# UNITED STATES PATENT AND TRADEMARK OFFICE

APPLICATION NO.	FILING DATE	FIRST NAMED INVENTOR	ATTORNEY DOCKET NO.	CONFIRMATION NO.
10/536,942	05/27/2005	Jan Rytter	13261.0029USWO	8305
23552 7590 02/07/2007 MERCHANT & GOULD PC P.O. BOX 2903 MINNEAPOLIS, MN 55402-0903			EXAMINER KEE, FANNIE C	
			ART UNIT 3679	PAPER NUMBER

<b>Office Action Summary</b>	<b>Application No.</b>		<b>Applicant(s)</b>	
	10/536,942		RYTTER, JAN	
	<b>Examiner</b>		<b>Art Unit</b>	
	Fannie C. Kee		3679

## **DETAILED ACTION**

Fig 1

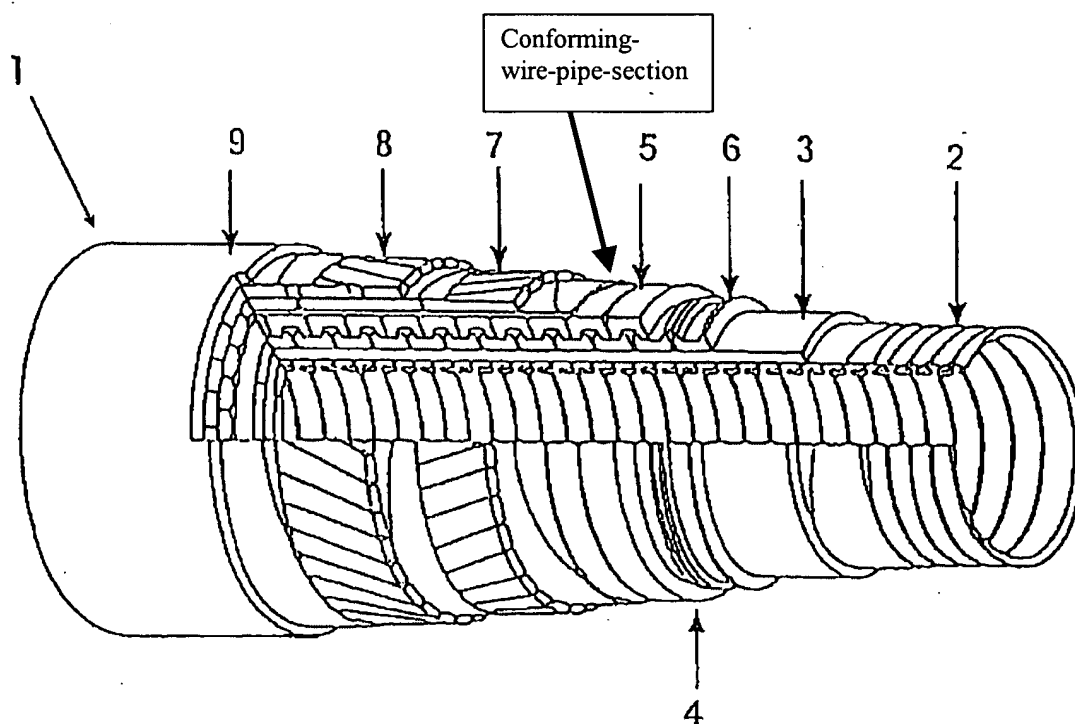
With regard to claim 1 and as seen in Figures 1 and 2 below, Glejbol discloses a pipe structure comprising a flexible pipe 1 connected to an end fitting 10, the flexible pipe comprising an armour layer 5 and an underlying pipe layer 3 to said armour layer, said underlying pipe layer having an outer surface around which armouring wires of an armouring layer are wound, the flexible pipe having a longitudinal axis wherein said end fitting comprises

With regard to claim 6, Glejbol discloses said underlying pipe layer of said flexible pipe comprising an armouring reinforcement 7,8 on a section of the pipe structure including said wire-pipe-exit-point and extending in a direction of the end fitting as defined by a direction from the flexible pipe towards the end fitting (Figure 1 above).

With regard to claim 22, Glejbol discloses said armouring wire or wires being in the form of a layered wire comprising two or more layers of materials 5,6 which may be identical or different from each other (Figure 1 above).

With regard to claim 24, Glejbol discloses said armouring wire or wires being in the form of a layered wire comprising two or more layers of materials 5,6 which layers being held together by a wrapping material and/or by adhesive forces 7,8 (Figure 1 above).

With regard to claim 26, Glejbol discloses said armouring wire(s) 5 being flat, said wire or wires having a square formed cross section, optionally a square formed shape with rounded corners (Figure 1 above).

With regard to claim 36, Glejbol discloses the pipe structure comprising a reinforcement sleeve layer 6 placed below the one or more armouring layer or layers (Figure 1 above), said reinforcement sleeve layer extends along the pipe structure in a length which include the section of the pipe structure between the wire-pipe-exit-point and the straight-line-end-point, and said reinforcement sleeve preferably extend along the pipe structure in a length which include the anchoring point or points on the end-fitting (Figure 2 above).

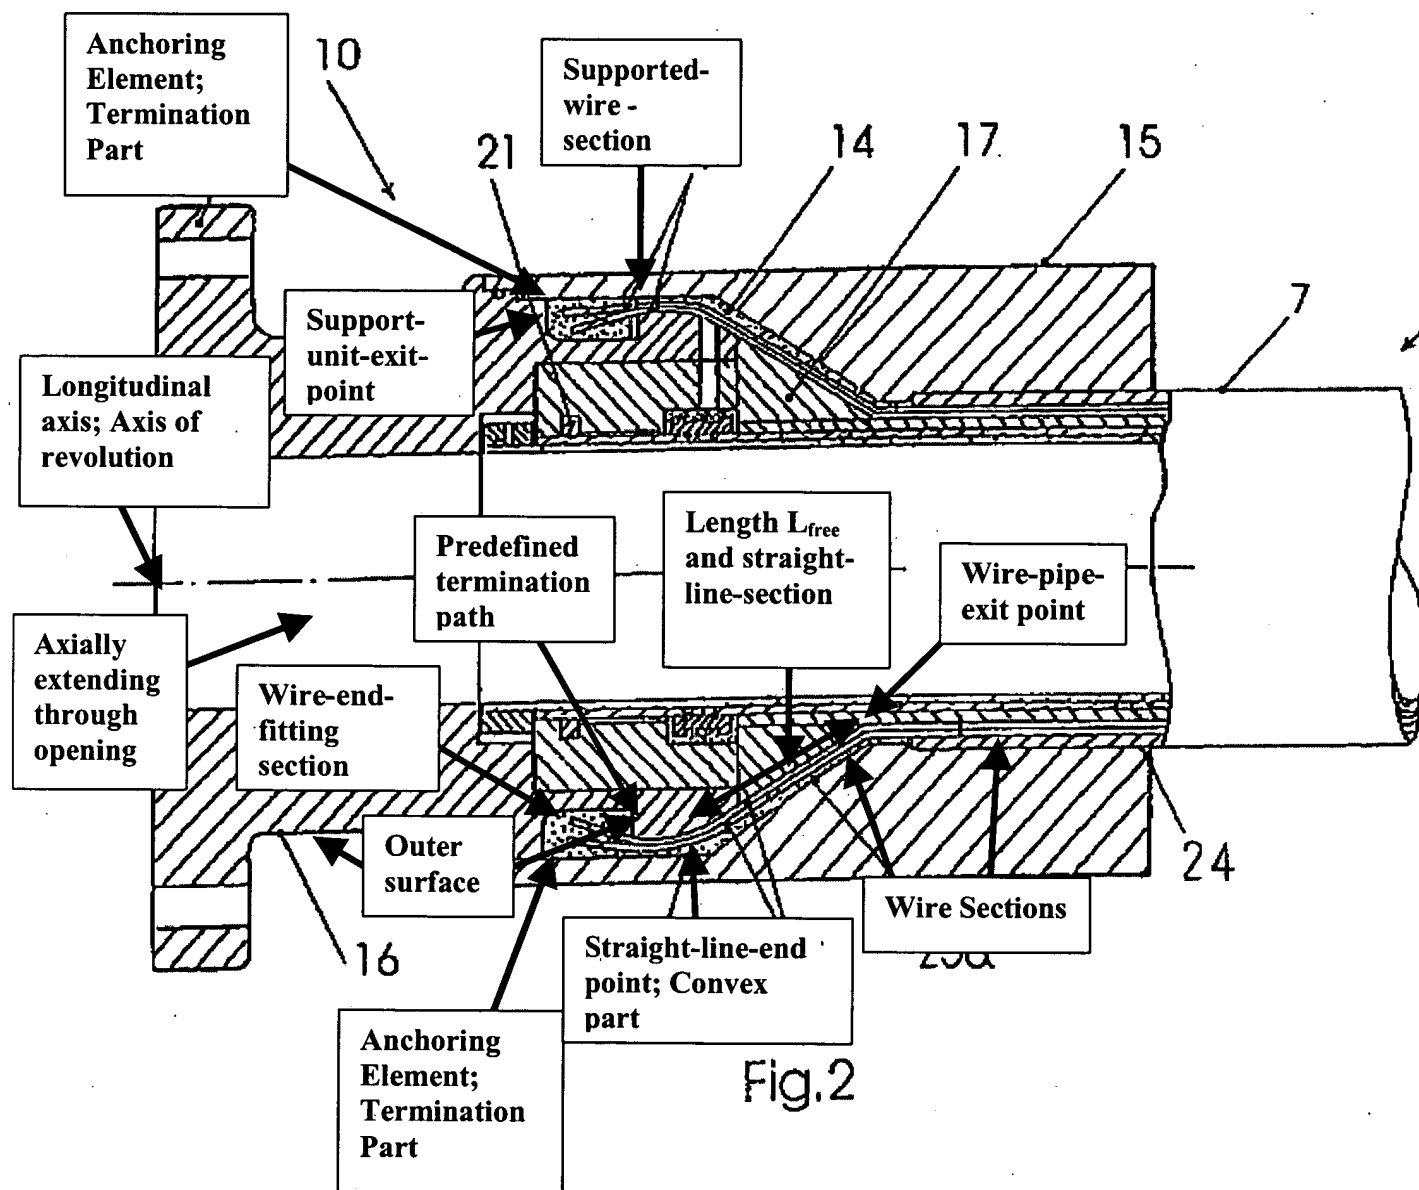
one or more anchoring elements (Figure 2 below) adapted for anchoring at least one of said armouring wires, and

a wire-end-fitting-section (Figure 2 below),

said two wire sections (Figure 2 below) extending in opposite directions from a wire-pipe-exit-point (Figure 2 below) where said armouring wire separates tangentially away from said underlying pipe layer, and

said wire follows an essentially straight line of a length  $L_{\text{free}}$  (Figure 2 below) between said wire-pipe-exit-point and a straight-line-end-point (Figure 2 below) on said support unit, said essentially straight line part of the wire being defined as the straight-line-section (Figure 2 below).

With regard to claim 2, Glejbol discloses said wire-end-fitting-section being arranged to follow a predefined termination path between said wire-pipe-exit-point and one of said anchoring elements when said pipe structure is in an unloaded condition (Figure 2 above).

With regard to claim 3, Glejbol discloses said straight-line-section is essentially unsupported between said wire-pipe-exit-point and said straight-line-end-point on said support unit (Figure 2 above).

With regard to claim 4, Glejbol discloses said straight-line-section extending away from said longitudinal axis when viewed from said wire-pipe-exit-point (Figure 2 above).

With regard to claim 7, Glejbol discloses said predefined termination path further comprising a supported-wire-section running on the outer surface of said support unit from said straight-line-end-point to a support-unit-exit-point where the armouring wire leaves the surface of said support unit for being locked in one of said anchoring elements, said supported-wire-section essentially constituting a geodetic curve between said straight-line-end-point and said support-unit-exit-point on said outer surface of said support unit (Figure 2 above).

With regard to claim 11, Glejbol discloses said support unit having an outer surface that describes a surface of revolution with an axis of revolution that coincides with the longitudinal axis of the flexible pipe (Figure 2 above).

With regard to claim 13, Glejbol discloses said support unit having a convex part with an outer surface with an outward curvature and said straight-line-end-point is located on said convex part of the support unit (Figure 2 above).

With regard to claim 18, Glejbol discloses said straight-line-section of an armouring wire being surrounded by a material 14 which does not substantially alter the deformation behaviour of the flexible pipe and the wire (Figure 2 above).

With regard to claim 27, Glejbol discloses each of the layers of the flexible pipe being fixed to said end- fitting (Figure 2 above).

Fig. 4

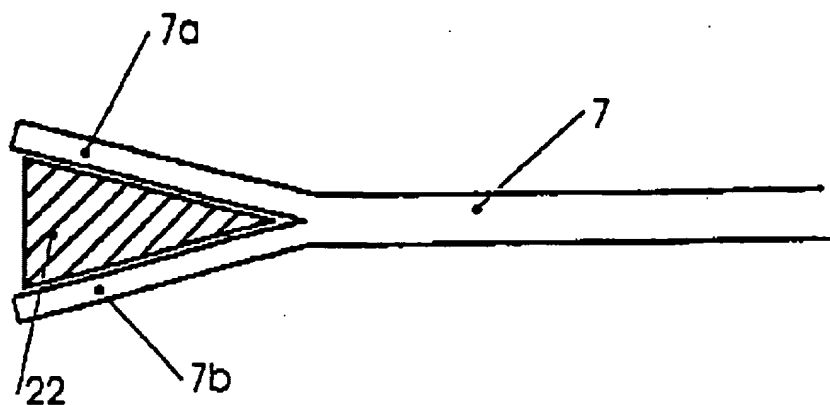
With regard to claim 31, Glejbol discloses the armouring wire or wires being anchored by use of a spreader element 22 driven into the wire or wires in said locking cavity or cavities (Figure 4 below).

With regard to claim 34, Glejbol discloses the armouring wire or wires 7 being anchored to the end-fitting by use of a spreader element 22 driven into the wire to thereby spread the wire into two or more laminates whereby the laminated wire or wires is fixed against the wall or walls of a locking cavity formed in the end-fitting (Figure 4 above).
